Murata Manufacturing Co., Ltd

Ref: PSE-14GA-0027 Date: March 31 2014

Subject: Notification for Change of Packing (SMD sounder: PKMCS series)

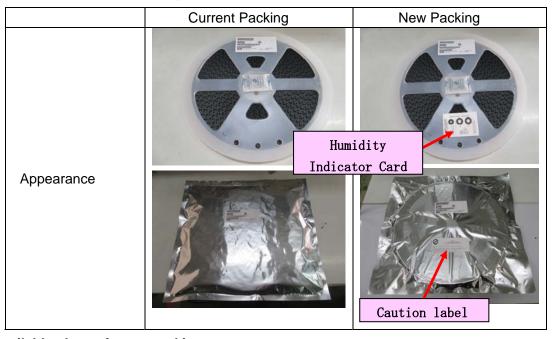
We will change into the packing required of the product of MSL2 as indicated in IPC/JEDEC J-STD-033C.

In accordance with this change, a humidity indicator and a cautions label are added.
